## DEVIATION REQUEST AND DECISION FORM

Project Name : Homestead North at Sterling Ranch Filing No. 1  
 Schedule No.(s) : 5228000030  
 Legal Description : See Exhibit B – Legal Description

A deviation from the standards of or in Section **ECM section 2.5.2 Pedestrian Facilities** of the Engineering Criteria Manual (ECM) is requested for the Jane Kirkman / Texas Jack T Intersection accessible curb ramp layout.

Exhibit A - ECM Fig 2-36

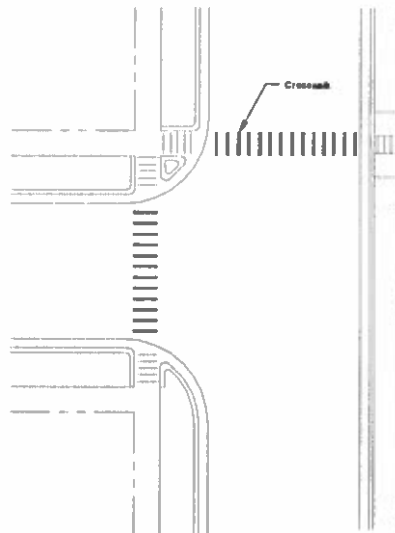
ECM Section 2.5.2.C.3 Accessible Curb Ramps at "T" intersections. All "T" intersections shall have a minimum of four curb ramps as shown in Figure 2-26 (Exhibit A)

EXHIBIT B  
 JANE KIRKHAM DR. DEVIATION  
 JOB NO. 25188.01  
 09/08/2022  
 SHEET 1 OF 1

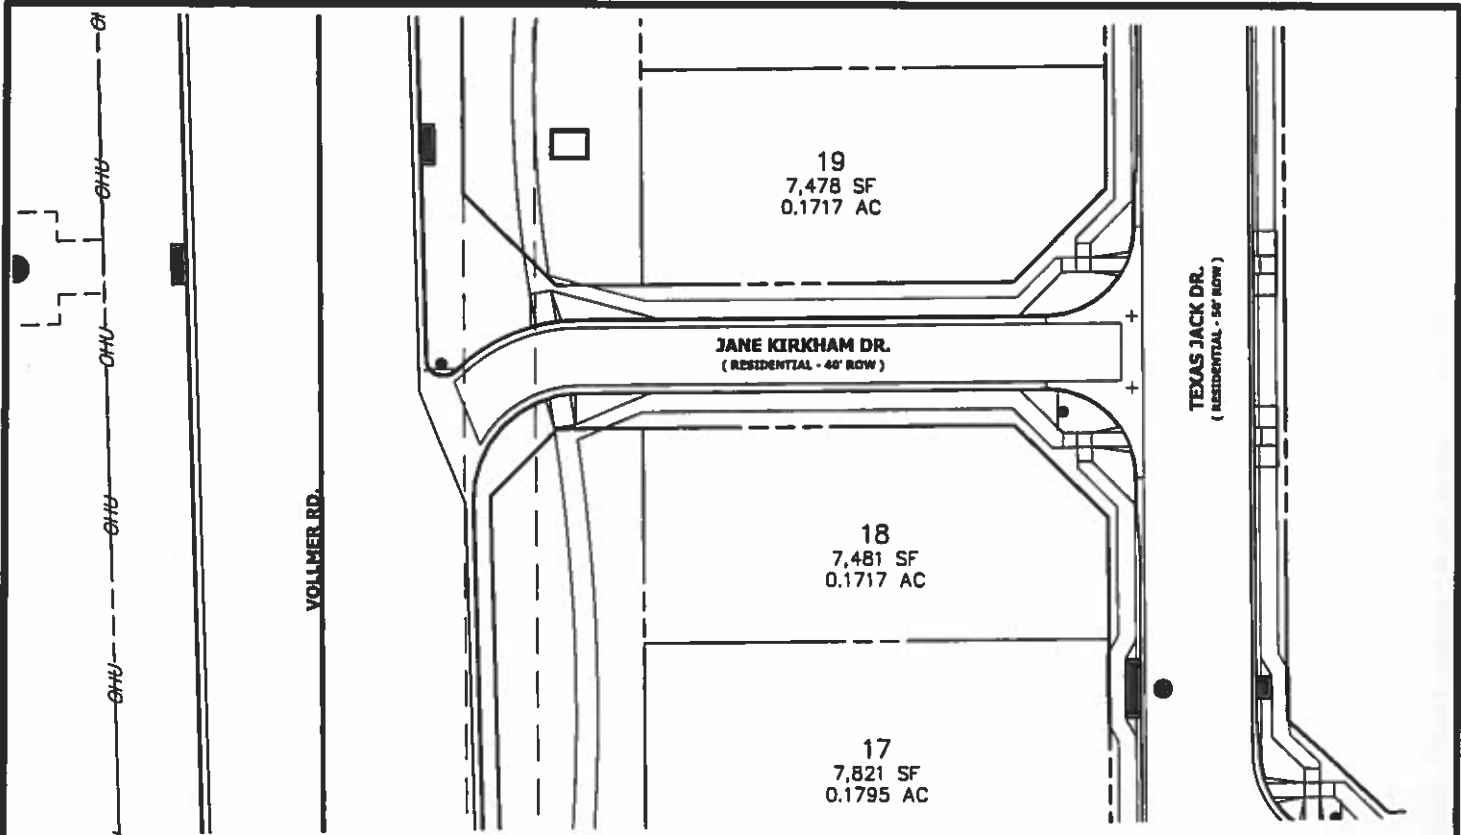
The south flowline slope of Jane Kirkman will exceed the accessible ramp cross slope standard of 2%.

See Exhibit A for a sketch of the proposed accessible ramp layout of for Jane Kirkman Drive and Texas Jack Drive.

To accommodate accessible access from north to south, ramps and a crosswalk will be placed across Texas Jack both north and south of Jane Kirkman Drive. There is also an accessible ramp and crosswalk crossing Jane Kirkman approximately 200 feet west near Vollmer Road.
